REQUEST FOR ADDITIONAL INFORMATION

REGARDING SPENT FUEL TRANSFER

ENTERGY NUCLEAR OPERATIONS, INC.

INDIAN POINT NUCLEAR GENERATING UNIT NOS. 2 AND 3

Review the thermal properties used to determine the thermal conductivity of saturated water vapor as a function of temperature. (TCB)

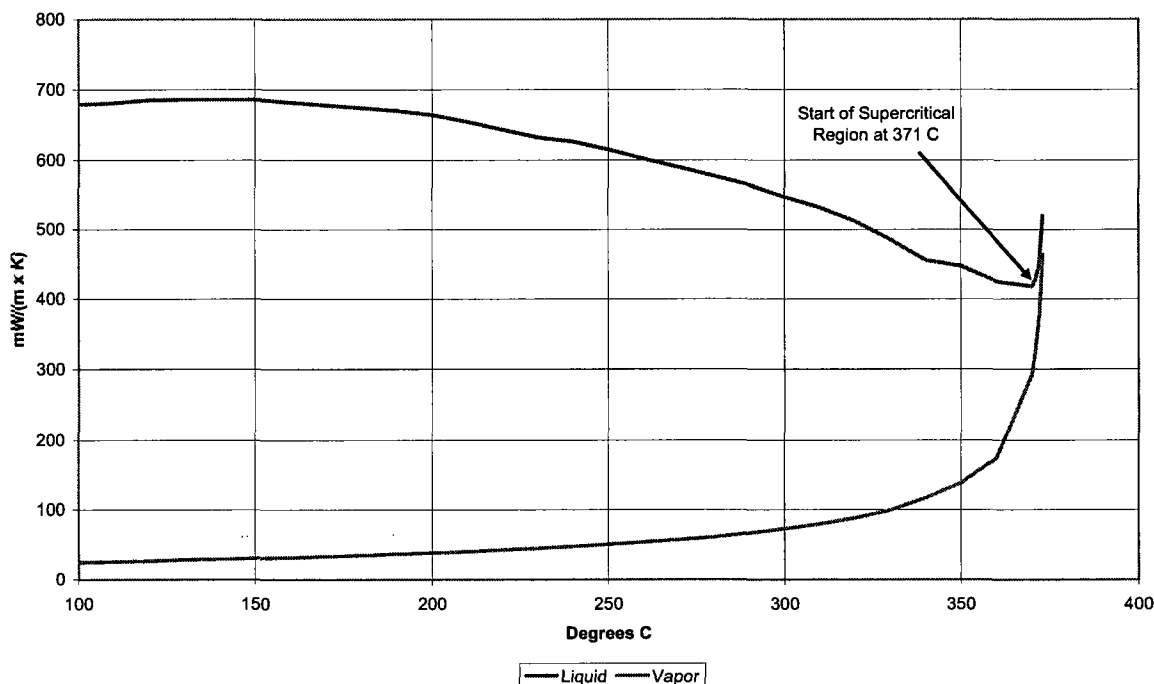
Page B-7 of Holtec report HI-2084146 provides saturated vapor thermal conductivity as a function of temperature. Thermal conductivity values tabulated at 371 C and 372 C appear to correspond to saturated liquid water. This may increase the effective conductivity at these temperatures.
